SHOREHAM NUCLEAR POWER STATION

SNRC 1512

Submission of Long Island Lighting Company's
Response to Generic Letter 88-11
NRC Position on Radiation Embrittlement Of
Reactor Vessel Materials And Its Impact
On Plant Operations
Shoreham Nuclear Power Station
Docket No. 50-322

FIGURE 5.2.4-2
SNPS-1 MINIMUM TEMPERATURES
REQUIRED vs REACTOR PRESSURE
SHOREHAM NUCLEAR POWER STATION
UPDATED SAFETY ANALYSIS REPORT

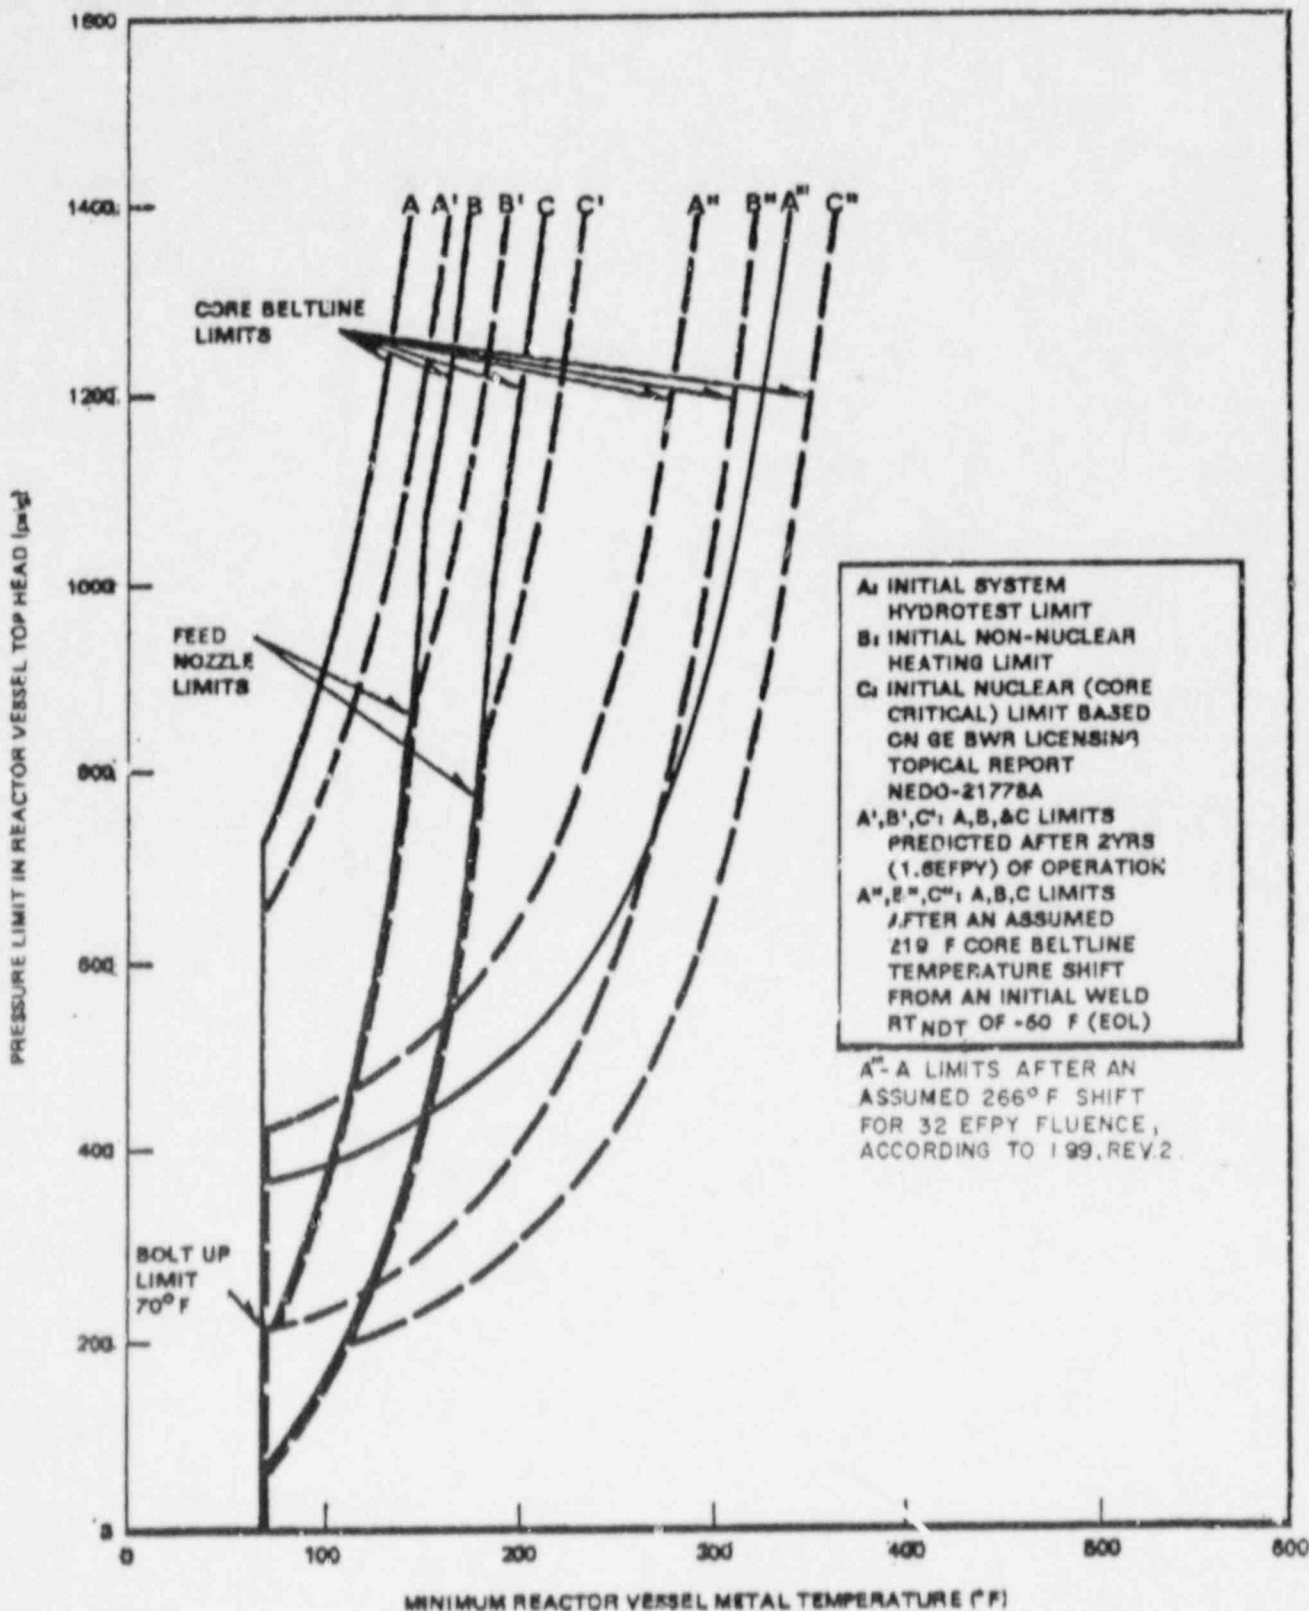
The impact of Regulatory Guide 1.99, Revision 2 on the SNPS reactor pressure test curve is shown on a mark-up of SNPS USAR figure 5.2.4-2, as attached. At 32 EFY, the 1000 psi leak test temperature (curve A'') for Regulatory Guide 1.99, Revision 1 is 250°F. Regulatory Guide 1.99, Revision 2 methodology increases the 1000 psi leak test temperature to approximately 300°F, as shown by Curve A'''. Since the reactor vessel can normally only be heated by pump heat, this temperature (300°F) cannot presently be achieved at SNPS. Obviously, this makes a very difficult situation even worse in Shoreham's case. To achieve the required 300°F, unless alternate heating methods are permitted, SNPS would potentially require the installation of additional auxiliary boilers and major piping modifications to directly deliver steam injection into the reactor coolant or to indirectly provide similar results through the use of large bypass type heat exchangers. This would require a large commitment of resources (i.e., time, money, material, and manpower) on LILCO's part.
